Planning and Zoning Board

GENERAL PLAN CASE #: ZON18-00181 (Minor General Plan Amendment)
ZONING CASE #: ZON18-00067 (Re-zoning and Site Plan Review)
LOCATION/ADDRESS: The 9500 thru 9800 blocks of East Hampton Road (south side).
GENERAL VICINITY: Located north of the US-60 Superstition Freeway and west of Crismon Road.
GENERAL PLAN REQUEST: Minor General Plan amendment to change Character Type from Employment to Neighborhood-Suburban.
ZONING REQUEST: Rezone from NC-BIZ, NC-PAD and PEP-PAD-CUP to RSL2.5-PAD and RM-3-PAD, and Site Plan Review; and consideration of the Preliminary Plat for "Bella Encanta"
PURPOSE: This request will allow for a small-lot, single-residence subdivision and multi-residence development.
COUNCIL DISTRICT: District 6
OWNERS: Crismon BFC LLC
APPLICANT: Pew and Lake, PLC
STAFF PLANNER: Lisa Davis, AICP

STAFF RECOMMENDATION: Denial of the Minor General Character Amendment
Denial of Rezone and Site Plan
Denial of Preliminary Plat

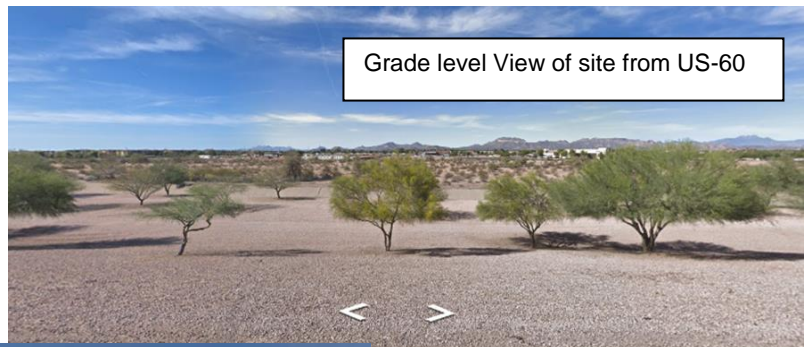
95% of the residential projects adjacent to the US-60 in Mesa have a berm or sound attenuation wall, inset to the right, between the freeway and the residential projects but that is not occurring at this

site. If a residential project were to be constructed at this site, design of the development needs to include adequate buffering from the grade level adjacent US-60 freeway. The east side of the project does propose a 15' building setback adjacent to the PEP-PAD site and a 30' setback is required. Staff is concerned with sustainability and livability for the project and is not in support of this modification.

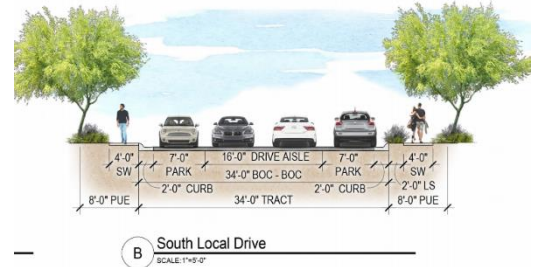
- The proximity to the US-60 Freeway, the adjacent Planned Employment Park to the east and Hampton Avenue have not been considered in the design of the project. Buffers from all have not been considered in the design.
- **Solid Waste-**The condominium units will have large bins for solid waste service. These bins are located adjacent to the small lot single residences and adjacent to the open space areas. The Mesa Zoning Ordinance (MZO) Section 11-30-12 provides standards for trash and refuse collection areas.

These standards include that the locations are reasonably equalized. Although the applicant shows that the bins are equally distributed, although far for the residents in the southern placed units. The placement of the bins adjacent to the small residential lots and next to the open space with residential houses and condos facing onto the areas are a concern. These areas can often become messy and unsightly. There is also concern for timing of the solid waste truck picking up the bins at 6 am adjacent to the homes. This is not a good design and is not supported by staff.
